SUBJECT: Responds to 860924 ltr requesting plant schedules for
 addressing plant-specific design features of ATWS mitigation
 sys actuation circuitry (AMSAC). Request for addl info re SER
 App A, "AMSAC Isolation Device" encl.

Donald C. Cook Nuclear Plant Unit Nos 1 and 2
Docket Nos. 50-315 and 50-316
License Nos. DPR-58 and DPR-74
GENERIC LETTER 83-28; 10 CFR 50.62, AMSAC

D. C. COOK PLANT-SPECIFIC RESPONSES

SER APPENDIX A, AMSAC ISOLATION DEVICE,
REQUEST FOR ADDITIONAL INFORMATION

FIGURE 1

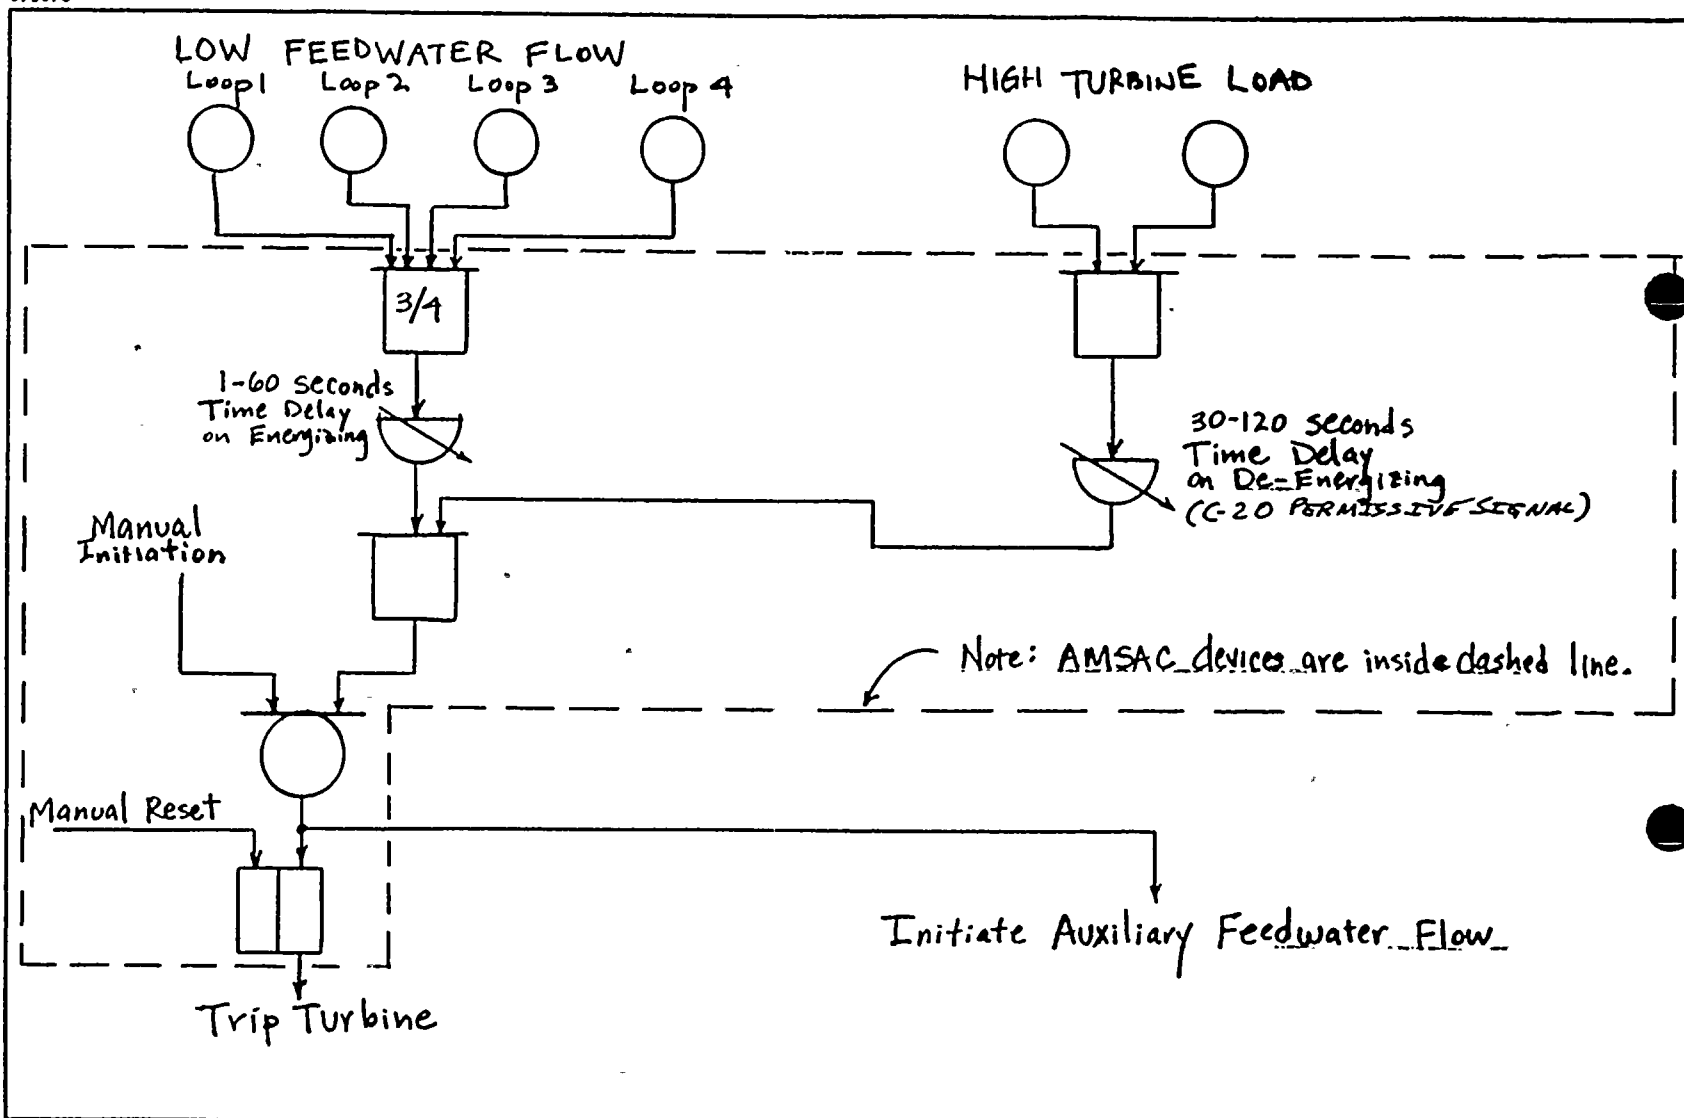
Attached are two figures: Figure 1 shows the generic Westinghouse Owners Group option chosen by the American Electric Power Service Corporation (AEPSC) for its AMSAC design; Figure 2 is a conceptual block diagram of AMSAC that shows its major features. We are in the process of developing design modifications separate from AMSAC that will limit steam dump to 40% or less during power operation. Therefore, the AMSAC system shown here does not contain provisions for limiting steam dump.
